SERVICE BULLETIN

NUMBER: DCI-EC130-IBF-SB01
Date: 12 July 2021

SUBJECT: BACKSHELL FASTENER REPLACEMENT

Inlet Barrier Filter (IBF) systems, produced by the Donaldson Company, Inc. (DCI), formerly Aerospace Filtration Systems, Inc. (AFS), for following helicopter models:

Figure 1 – Location of Backshell Screws Recommended for Replacement (I)

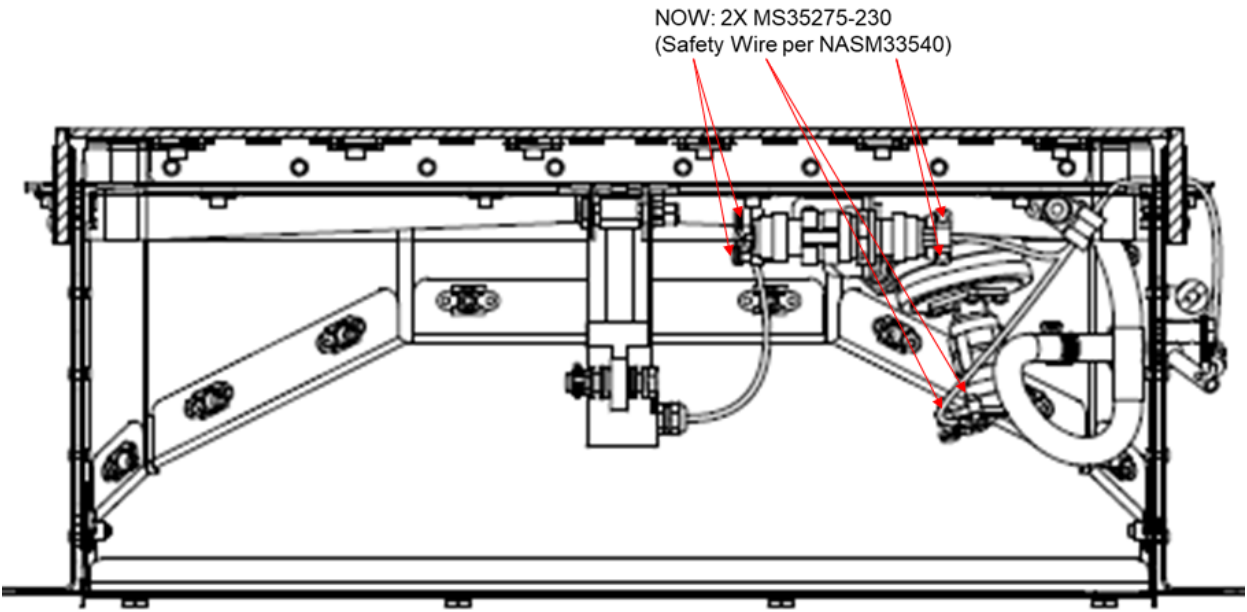
This is not a safety of flight issue, if operators follow Section 8.5.5.2 of the Instructions for Continued Airworthiness (ICA) and verify that Backshells are secure during regular maintenance intervals, then it is highly unlikely that the Backshell fasteners will come loose during flight. Nonetheless, Donaldson recommends a product improvement for all operators of the DCI EC130 IBF by replacing the existing fasteners on the Backshells of the 106113-205 Actuator and the 121400-101 Wire Harness with MS35275-230 screws and to safety wire the screws per NASM33540. Location of these screws can be found depicted in Figures 1 and 2. Inspection requirements for the Backshells will remain the same unless otherwise directed by a newer revision of the ICA (Reference 1).

Operators are recommended to locally procure the replacement hardware as applicable. If local procurement is not available, operators can procure the screws from Donaldson's ecommerce site found in the Contact section.
